Linn Park, Glasgow

Rock Slope Geotechnical Assessment and Remedial Options Appraisal Report

372568-01 (01)

Freedom of Information request raised 12th April 2022
by Eur Ing Richard Townsend-Rose.
Document received 13th May 2022
Document commented upon thereafter.

Figure 1: Site Location Plan

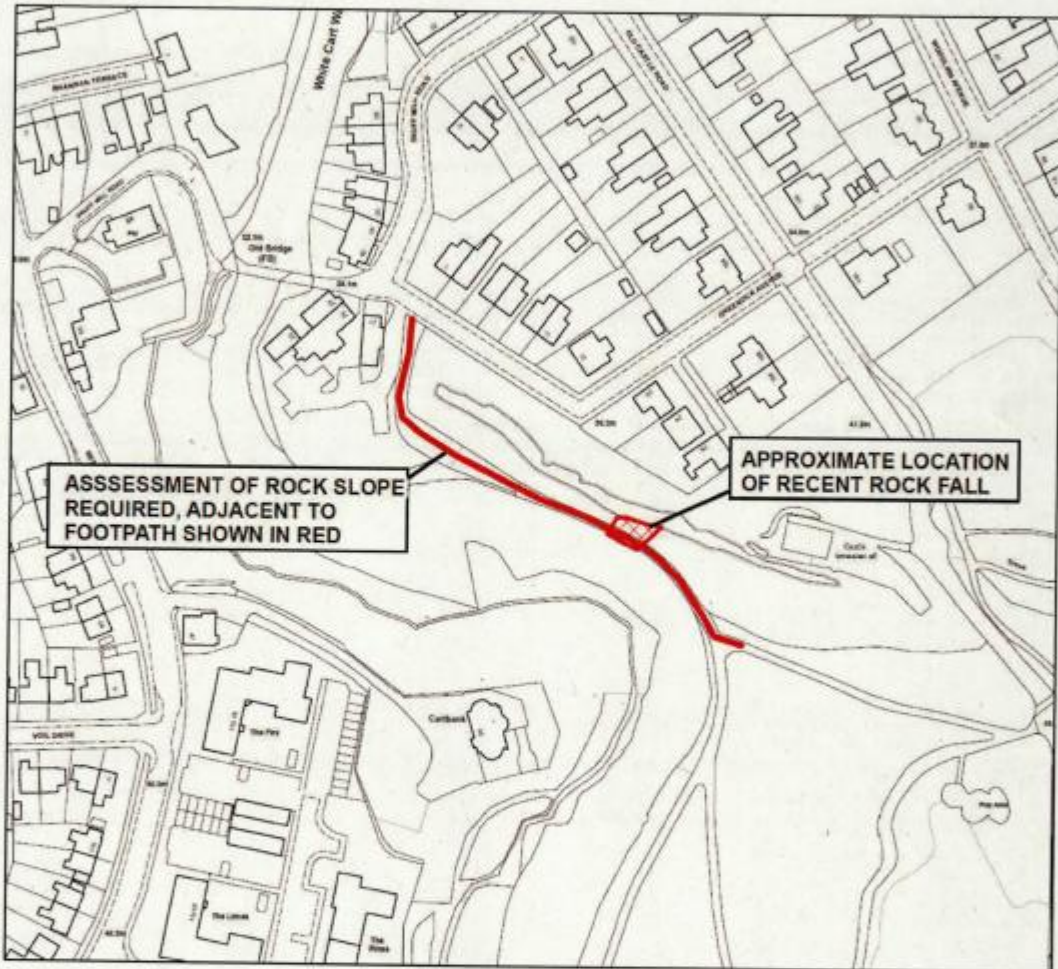
Chainage of
rock fall 115m

Description: SLOPE SECTIONS

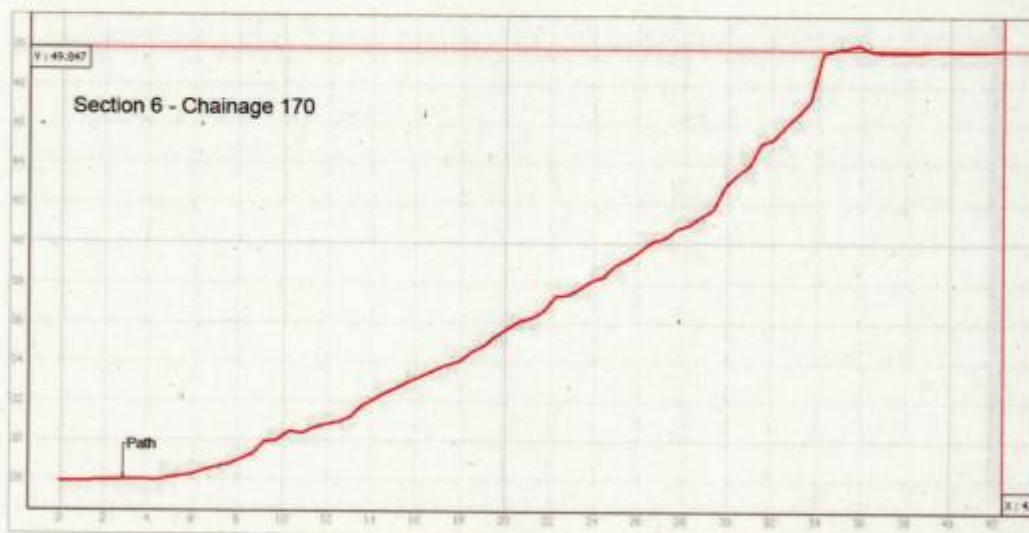
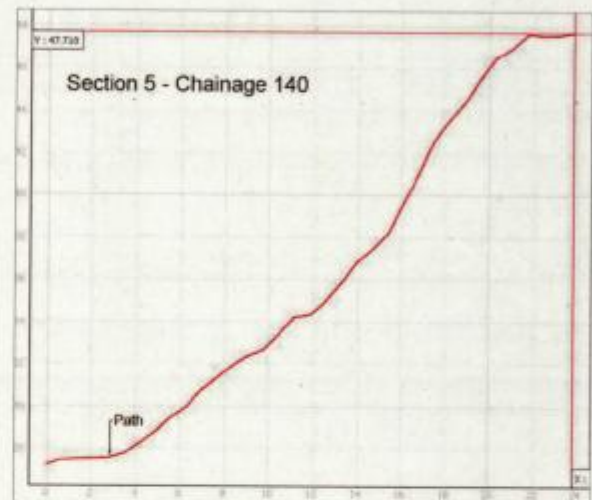
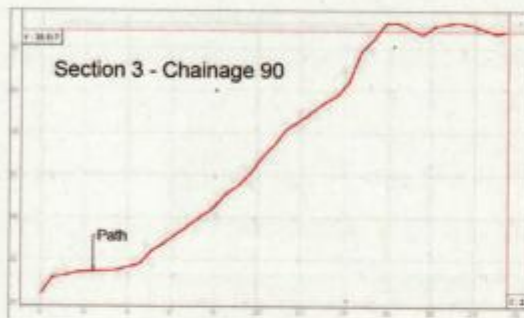
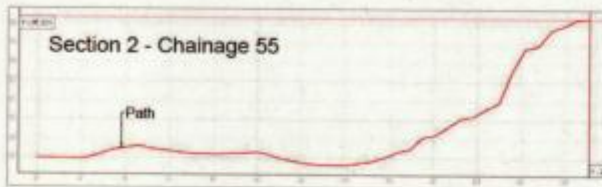
At the rockfall
